STATE BUILDING CODE TECHNICAL REVIEW BOARD

Friday, August 15, 2025 - 10:00am

1. On February 14, 2025, the Fairfax County Department of Land Development Services (County), the agency responsible for the enforcement of Part 1 of the 2021 Virginia Uniform Statewide Building Code (VUSBC), denied a permit/plan review for BLDC-2024-00163 pertaining to the design of the project known as Eastgate Mixed Use submitted by Campbell Code Consulting (Campbell) which had only one exit. The determination of the County was that two exits were required due exit remoteness pursuant to VCC Section 1007.1.1 *Two exits or exit access doorways*.

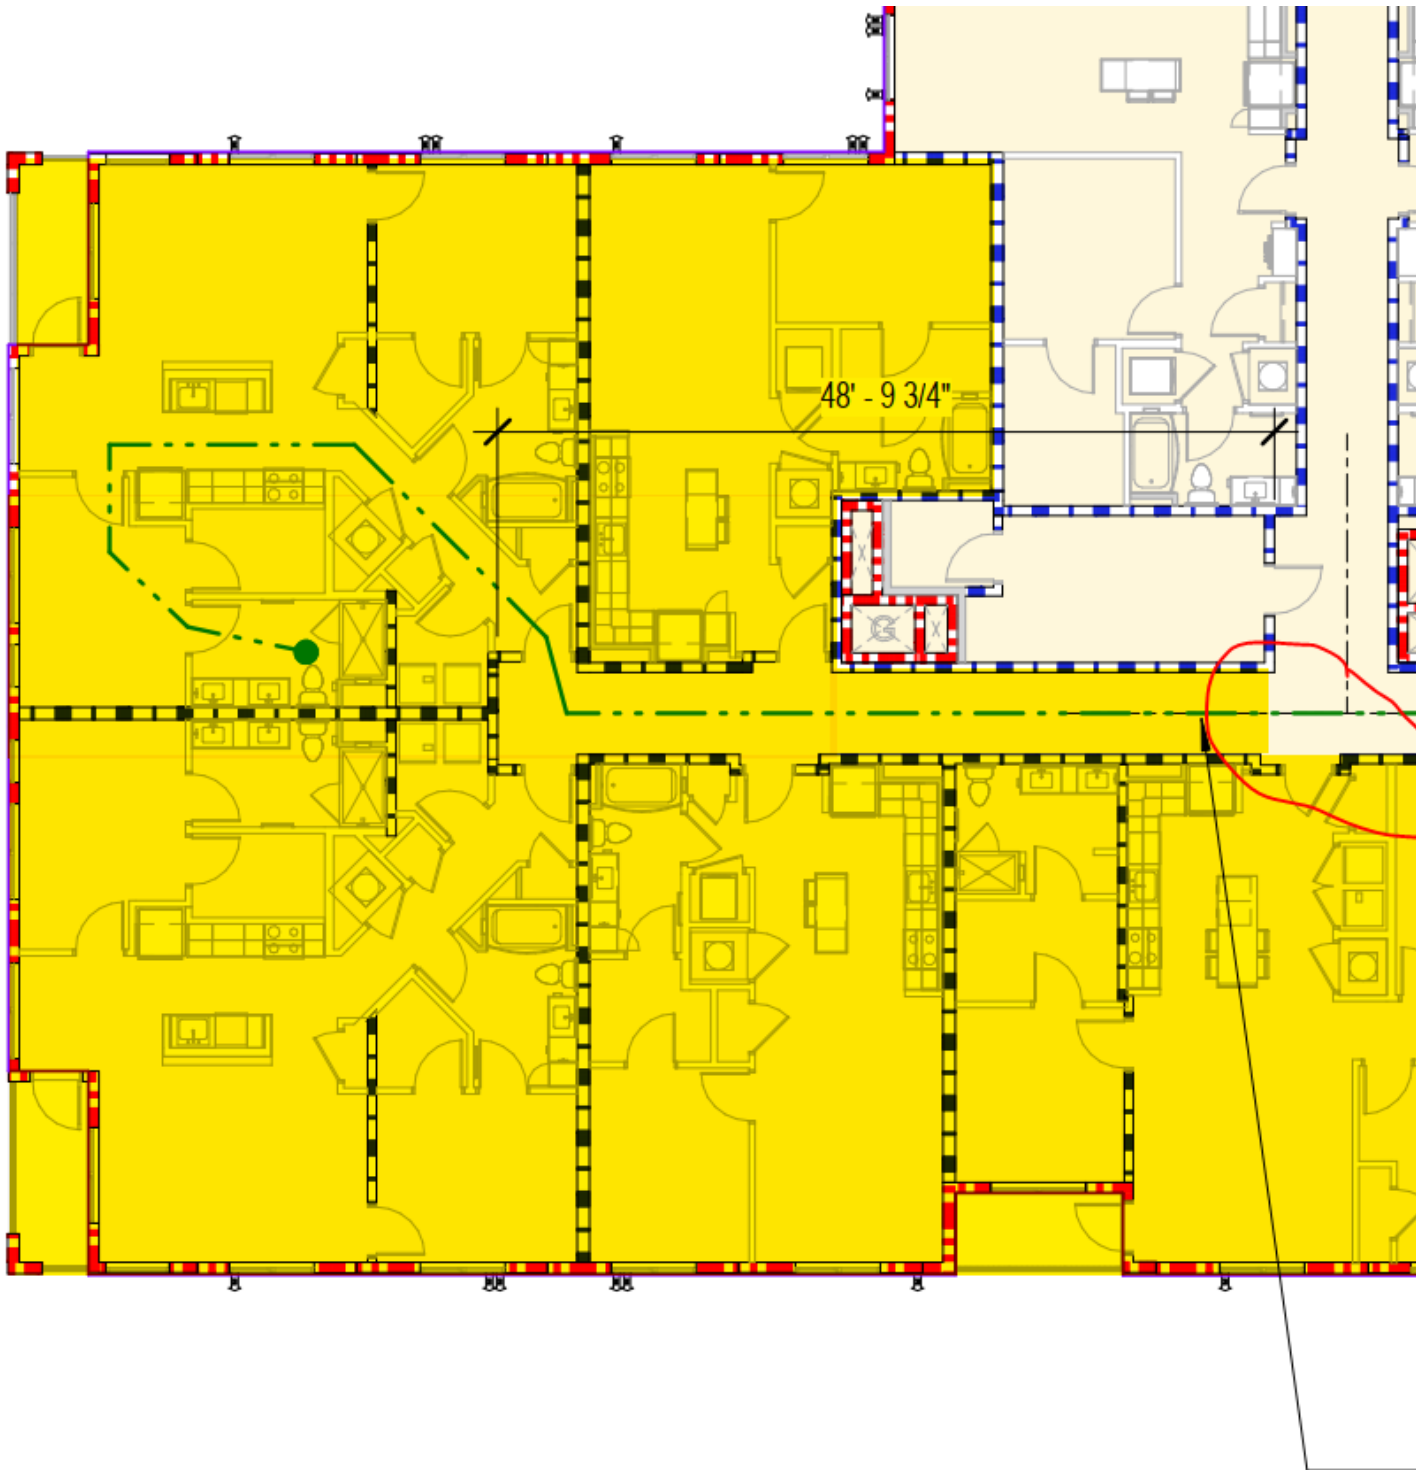
2. Dan's opinion is that the "space" measurement for the purposes of 1006.2.1 would be as shown below. This measurement incorporates an entire additional unit, is over 4,000 SF, and therefore over 20 occupants. Dan then believes a second exit access point is required from this space.

In my mind, the question is really hinging on the unit with an entry door right below the corridor intersection point. My take is that because occupants in this unit have zero common path immediately upon walking out of the unit, this unit should not be included in the “space” with only one exit. But Dan disagrees.
